Comments on  
**Draft Supplemental Environmental Impact Statement (DSEIS) proposed Campo Regional  
Landfill Project on the Campo Indian Reservation in San Diego County, California**

Dated February 26, 2010.

G. Fred Lee, PhD, BCEE, F.ASCE and Anne Jones-Lee PhD

April 29, 2010

PROPOSED SITE  
GEOLOGY

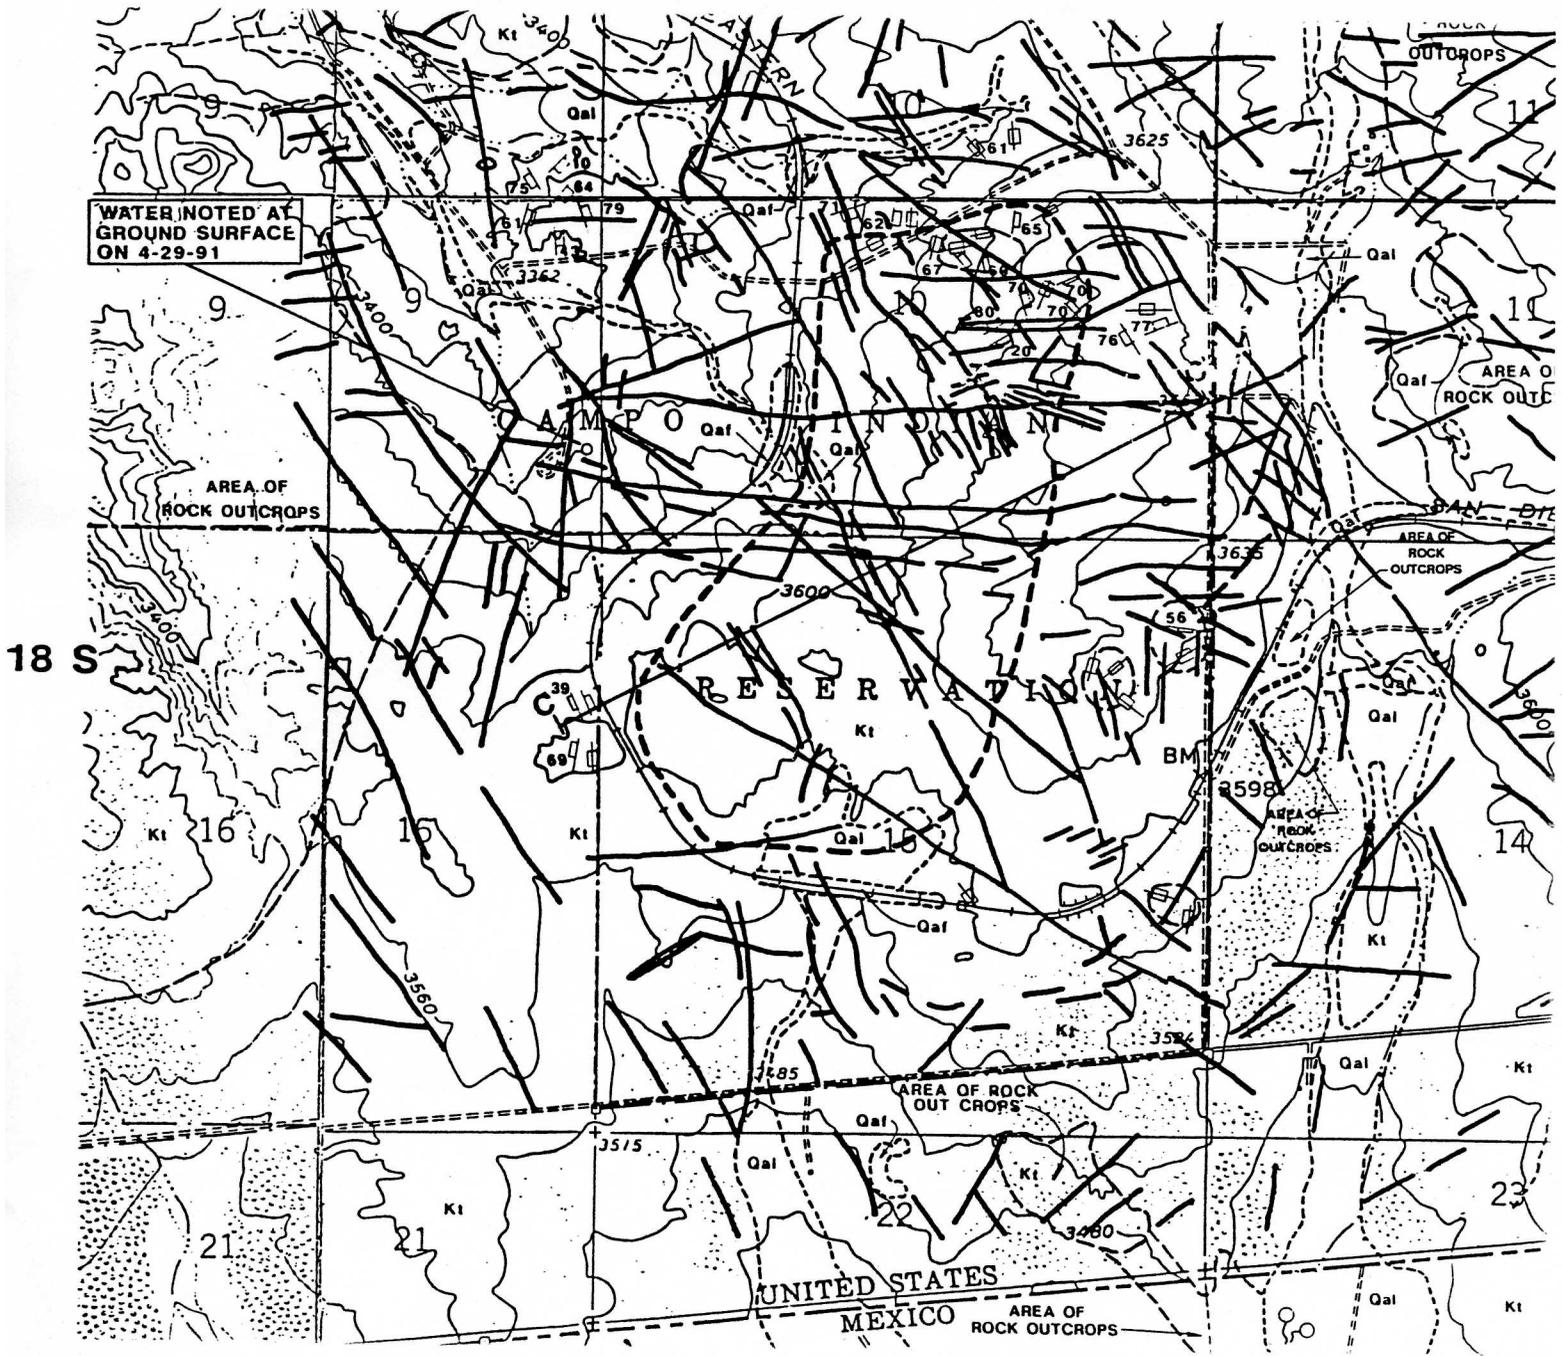
The maps of fracture traces at the site of the proposed landfill that are attached to the US EPA January 4, 1993 letter appended to these comments that were developed by a consultant to the Campo Landfill clearly show several fracture traces that cross the proposed landfill site some of which are connected to the offsite properties to the **adjacent** the proposed landfill. These fracture traces could readily serve as pathways for leachate that will eventually pass through the landfill liner system to rapidly be transported in groundwater to the east of the proposed landfill and pollute adjacent properties groundwaters and water supply wells.

PRELIMINARY MAP PROVIDED  
 TO ED + DONNA TISDALE BY  
 DANES + MOORE WHEN THEY  
 WERE WORKING ON CAMP LANDFILL  
 NOTE HOW MANY MORE FRACTURES  
 ARE SHOWN THAN IN THE FEIS MAP
